# Duquesne Light Company

Reference: Beaver Valley Power Station, Unit No. 1  
Docket No. 50-334, License No. DPR-66  
Responses to R. G. 1.97 Evaluations

## ATTACHMENT 1

### Steam Generator Wide Range Level Instrumentation

**SHEET E**  
CONTINUED FROM SHEET A

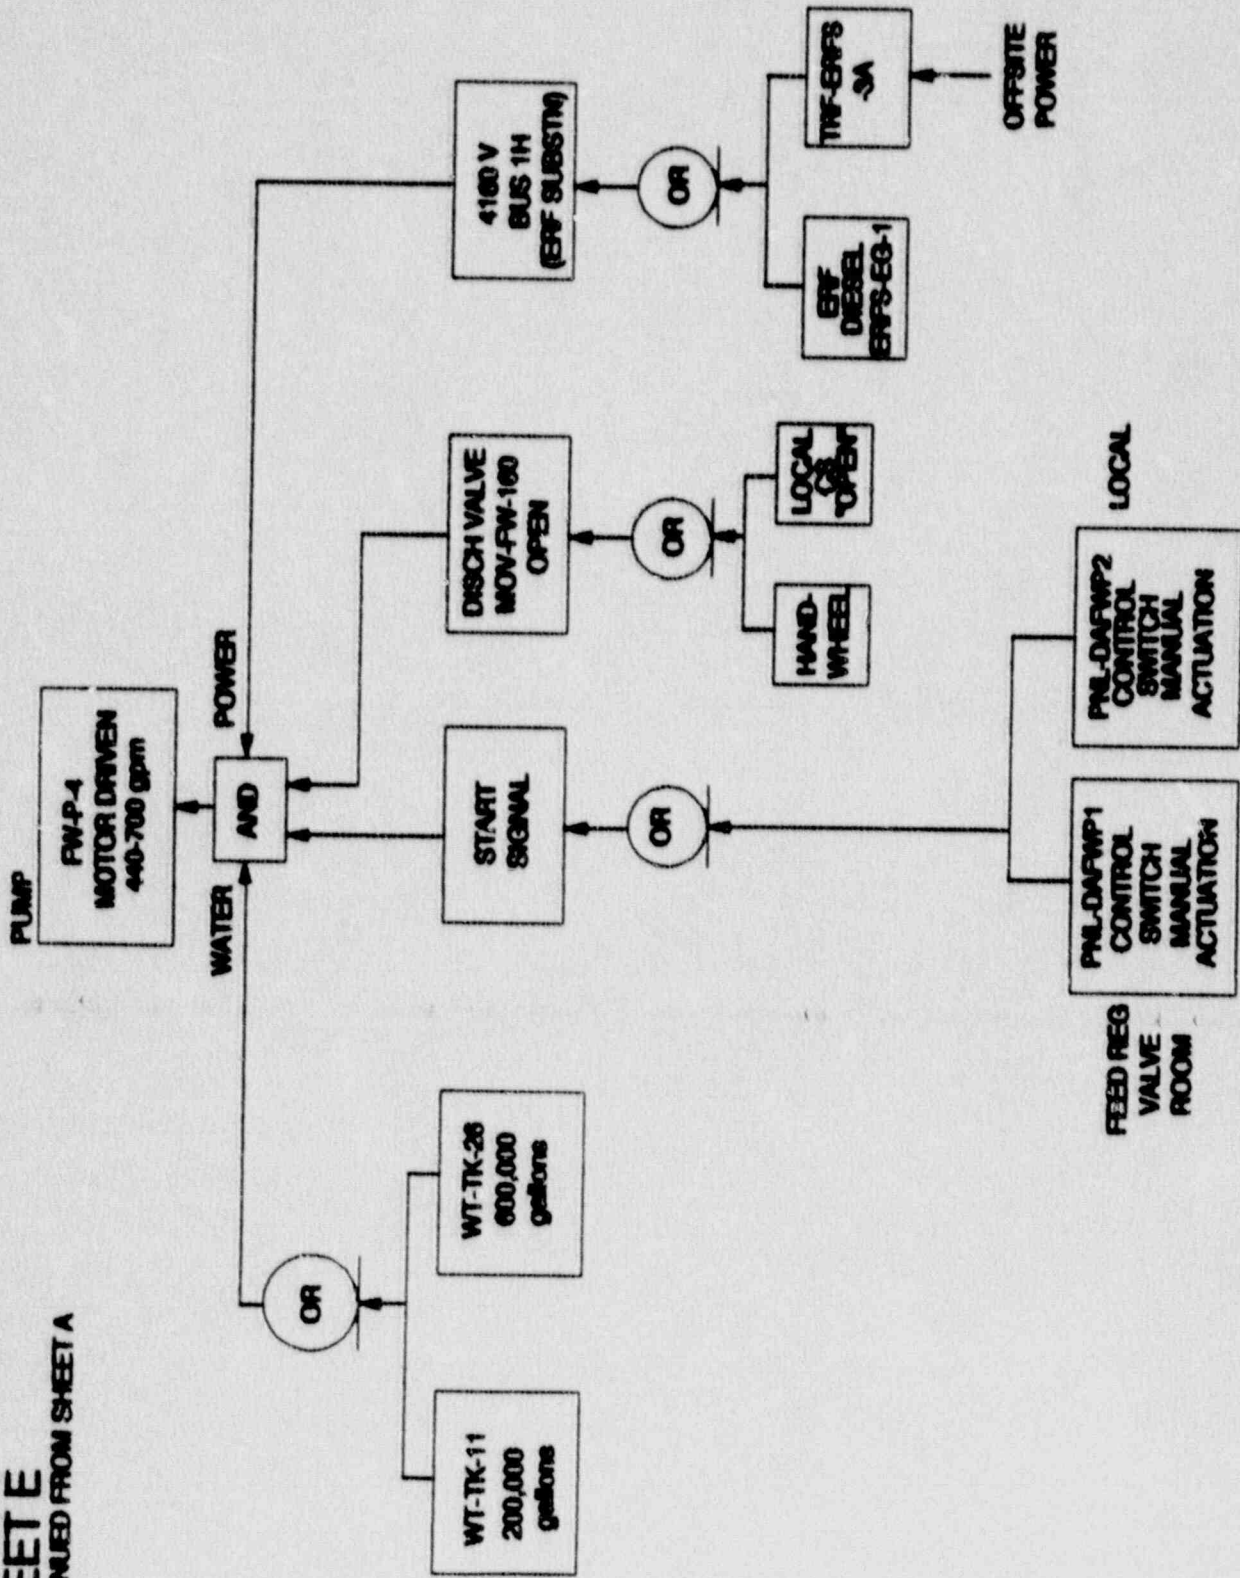
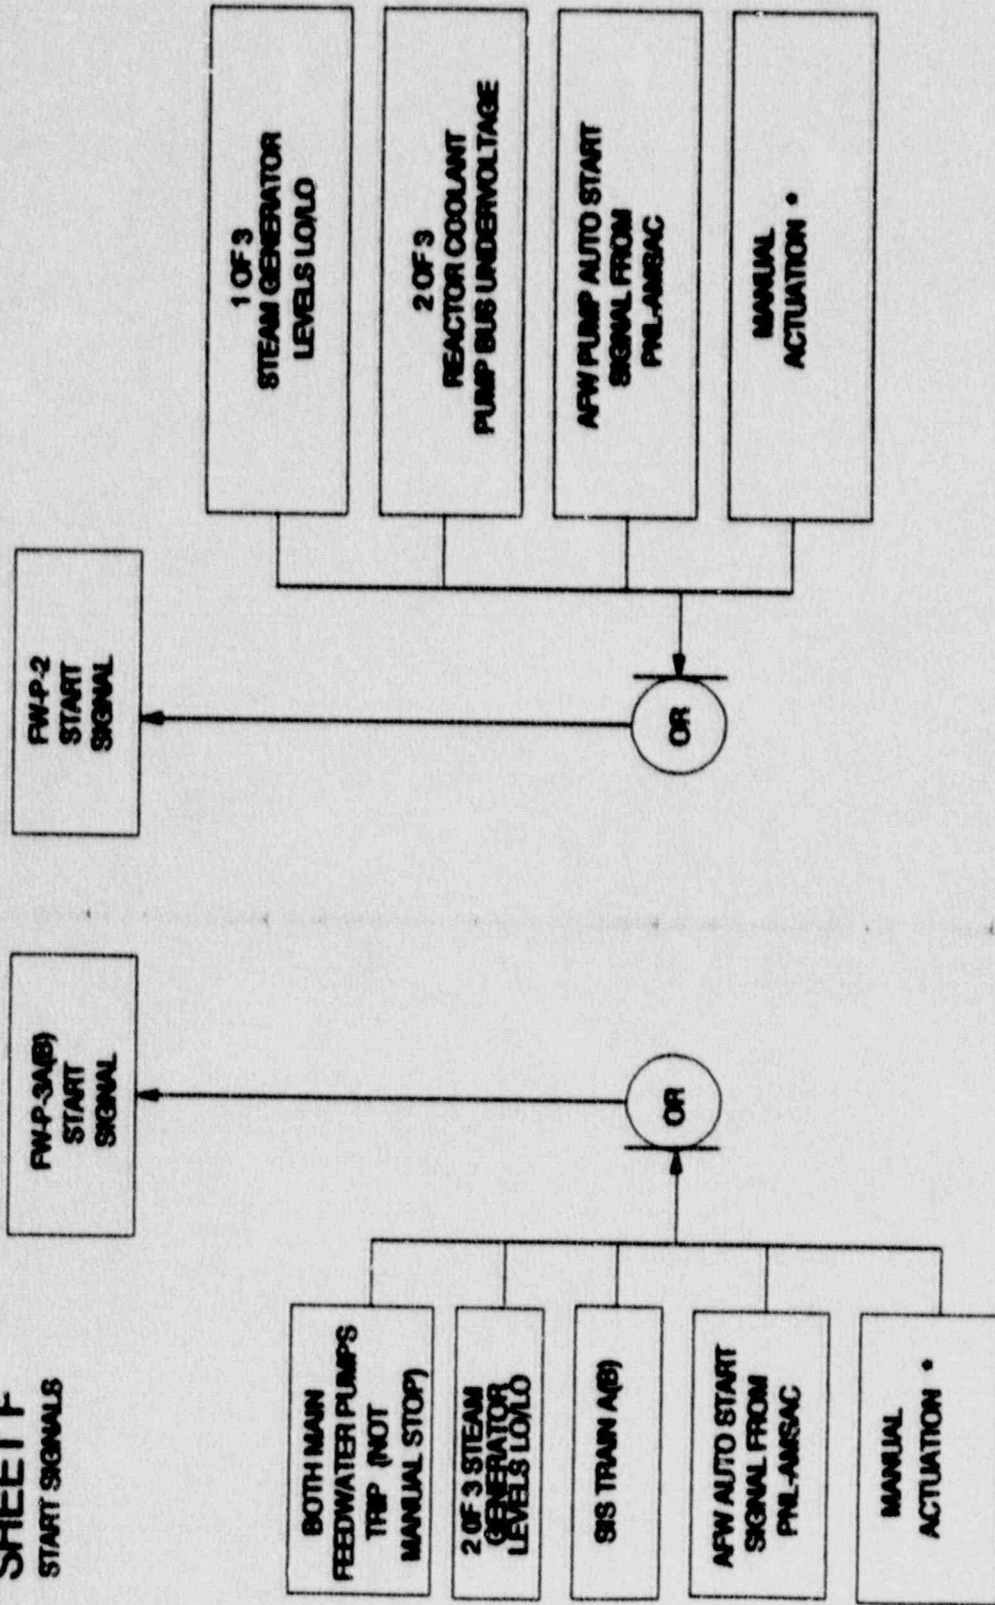
Figure 2 to this attachment provides the logic model which we developed to show that the procedures are supported by the BVPS-1 design. The figure shows that additional systems are available to mitigate conditions leading to steam generator dryout. The logic model shows several success paths for supplying 350 gpm of auxiliary feedwater to any steam generator. The system is supplemented by an additional auxiliary feedwater pump, FW-P-4, which was included to satisfy Appendix R. The 4160V electrical supply for the auxiliary feedwater system will have another power source added for Station Blackout. The model also shows the redundancy of the river water supplies.
